Attached please find "*Former Fuel Offloading Rack (FFOR) Step-Out Conflicts, Addendum to Interim Measures Work Plan, Bulk Fuels Facility Spill, March 2011, Bulk Fuels Facility Spill, Solid Waste Management Units ST-106 AND SS-111, April 2013*". The addendum addresses resolution of conflicts between planned FFOR step-out sample locations and existing underground utilities.

**Former Fuel Offloading Rack Step-Out Conflicts
Addendum to Interim Measures Work Plan, Bulk
Fuels Facility Spill, March 2011**

**Bulk Fuels Facility Spill
Solid Waste Management Units ST-106 and SS-111**

**Subject: Former Fuel Offloading Rack Step-Out Conflicts
Addendum to Interim Measures Work Plan, Bulk Fuels Facility Spill, March 2011
Solid Waste Management Units ST-106 and SS-111
Kirtland Air Force Base, New Mexico**

STEP OUT LOCATIONS IN CONFLICT WITH
UNDERGROUND UTILITIES AND
PROPOSED NEW LOCATIONS

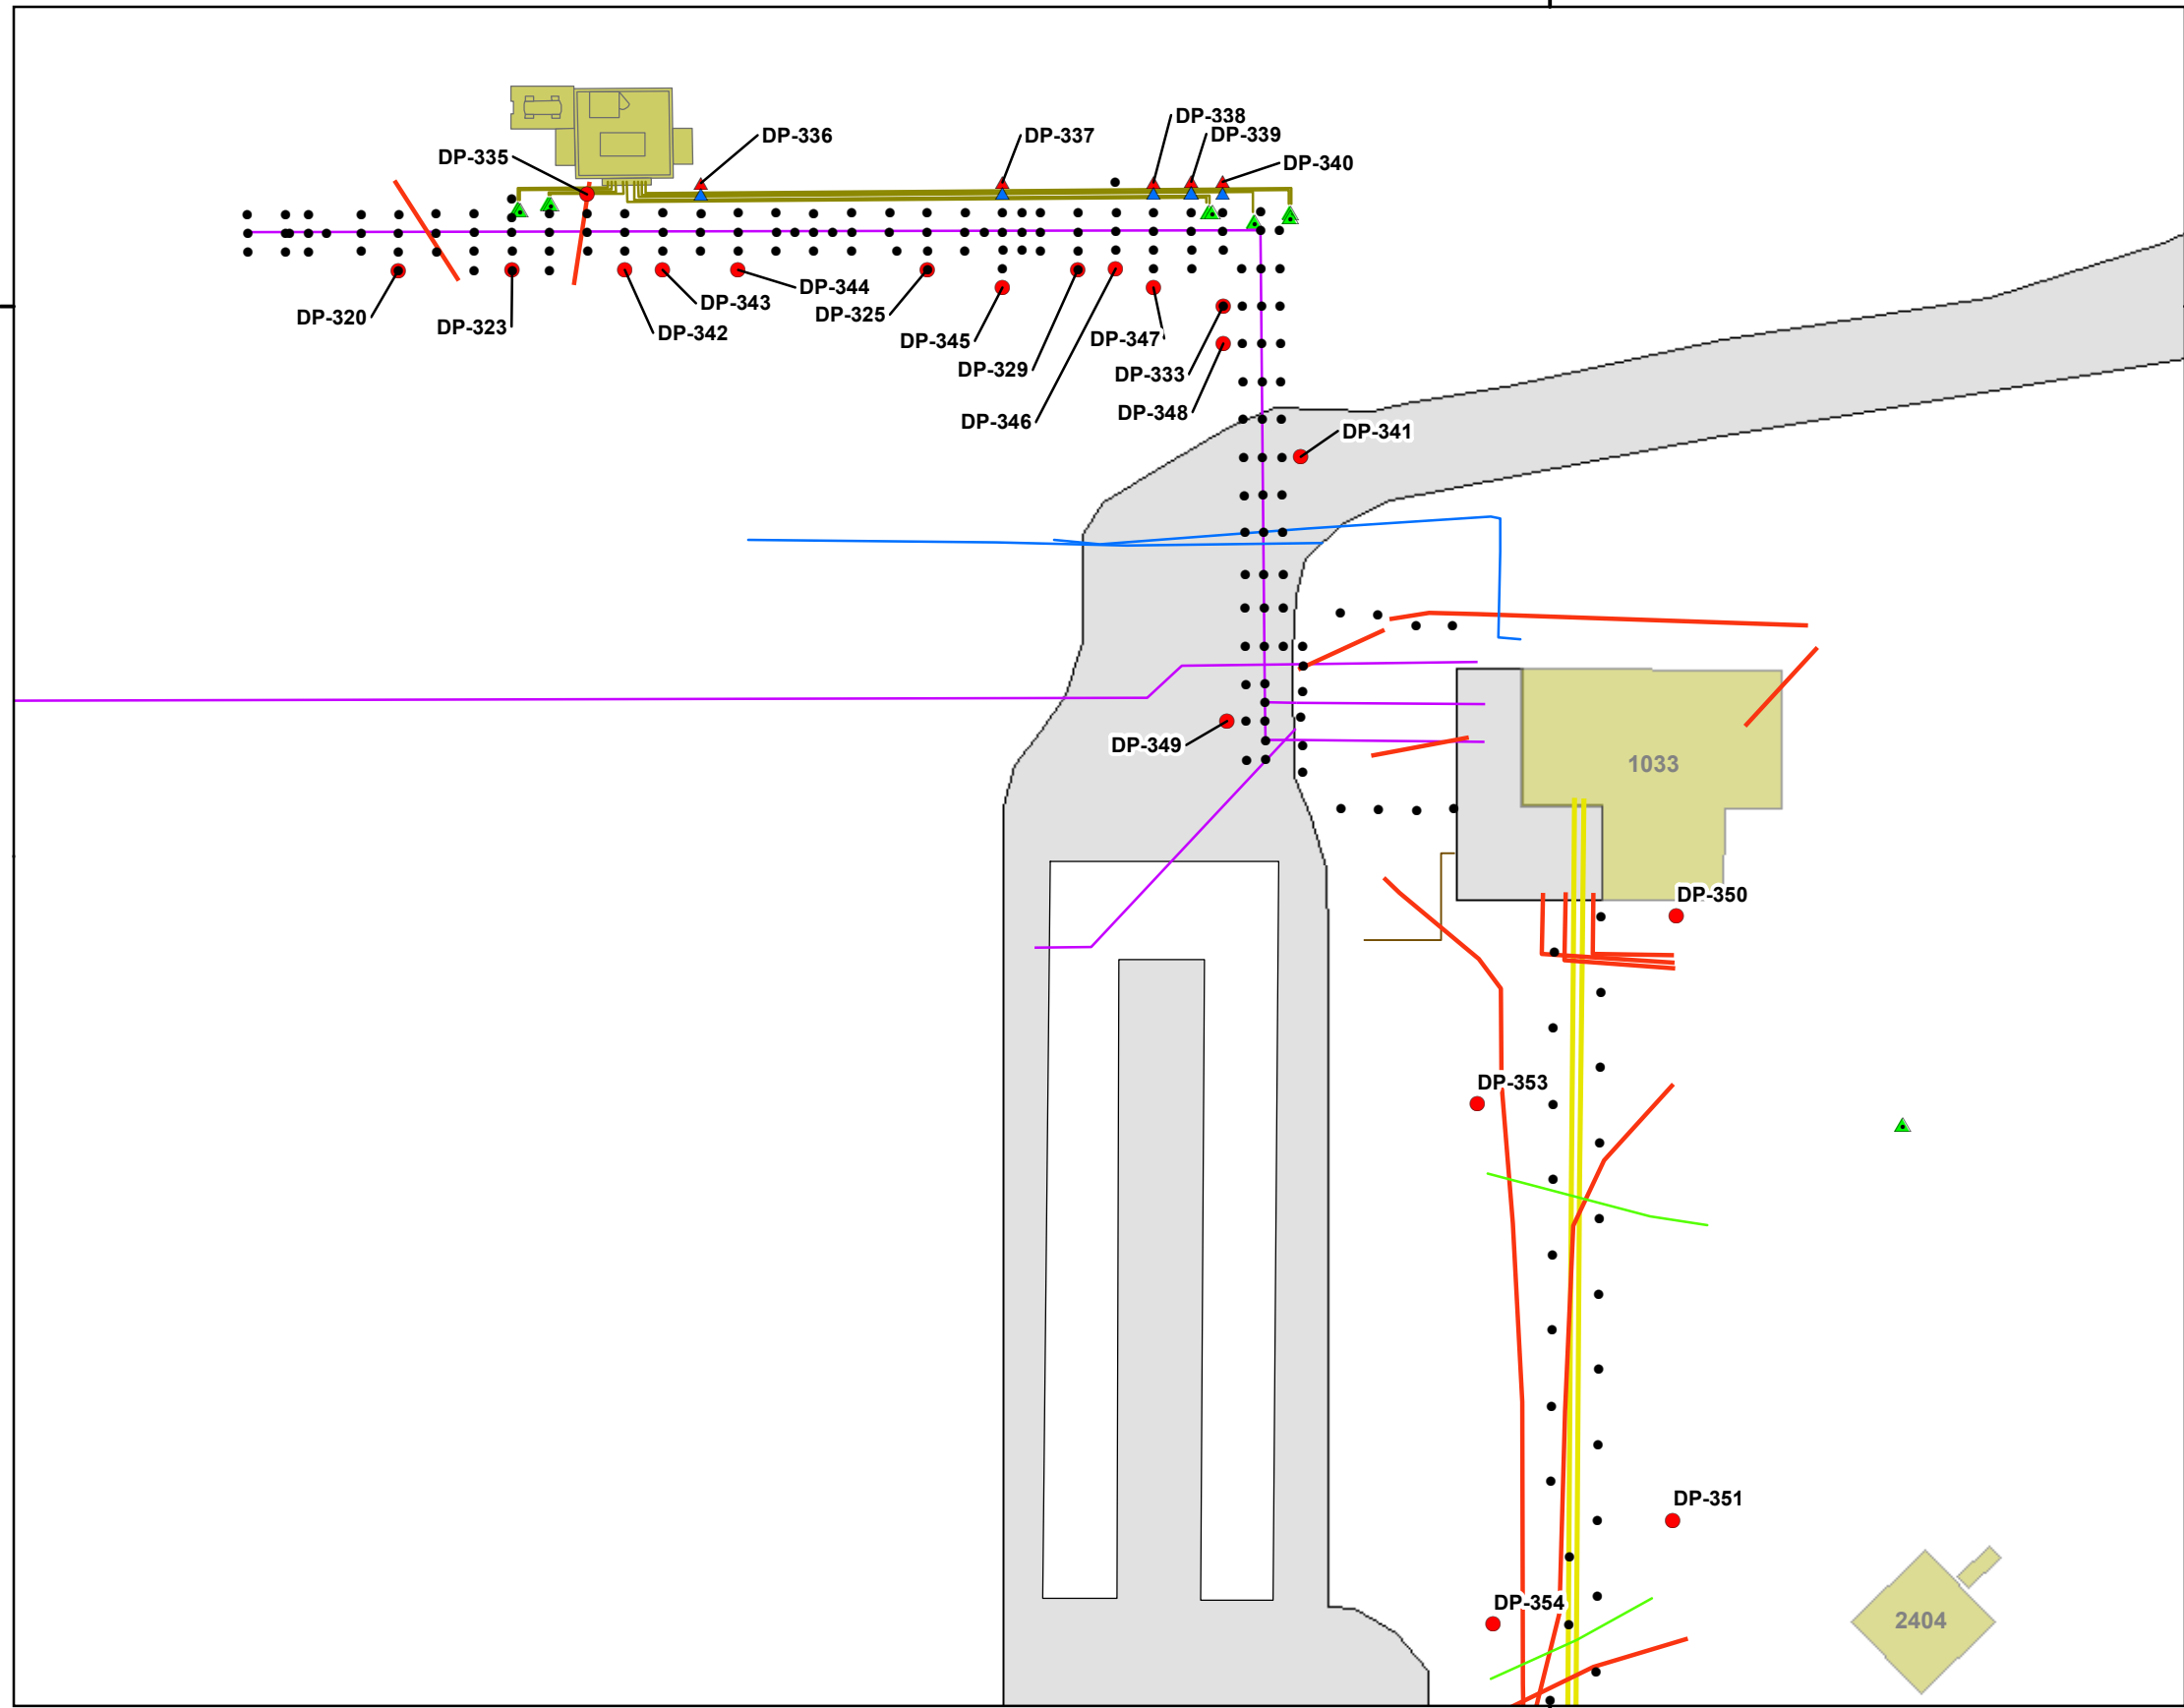
Following the initial soil investigation and step-outs, New Mexico Environment Department revised the Soil Screening Levels. Subsequently, Shaw has identified 28 locations where additional step-out samples are necessary to delineate exceedance zones. In November 2011 a utility locate survey was performed. It established that there are five proposed step-out locations that are in conflict with existing underground utilities (Figure 1). The proposed locations for these step-outs, identified in accordance with Shaw's Interim Measure Work Plan (March 2011), are directly above infrastructure that links soil vapor extraction (SVE) wells to an SVE system. Advancing this borehole would not only shut down, and cause damage to the SVE system at the FFOR, but could potentially release combustible hydrocarbon vapors. Shaw proposes the following steps to collect the step-out without impacting the SVE system:

1. Shaw will move five proposed step-out locations (DP-336, DP-337, DP-338, DP-339, and DP-340) 3 feet to the north (Figure 1).
2. Locations will be hand augered to 5 feet bgs to ensure no utilities are disrupted from drilling activities. In locations where a surface soil sample is required from 0 to 1 foot bgs, the sample will be taken following Shaw's Hand Auger Sampling Standard Operating Procedure. The sample will be augered with a clean auger head from 0 to 1 foot bgs. Once the auger head has been removed from the ground, the depth to the sample bottom will be measured and compared to the desired sampling depth. If the upcoming drill interval is expected to represent the sampling depth, the auger head will be decontaminated prior to drilling the sample interval. Once drilled, if the material represents the desired depth, it will be placed into a sample bowl. The material in the bowl will be homogenized and transferred directly into the sample container(s). The container will be capped, labeled, documented, and placed into a sample cooler. No volatile organic compound samples need to be collected for these step-outs in the first 5 feet.

3. During excavation, Shaw will hand excavate around the SVE conduits, and will develop an excavation plan to minimize the possibility of damaging this infrastructure.
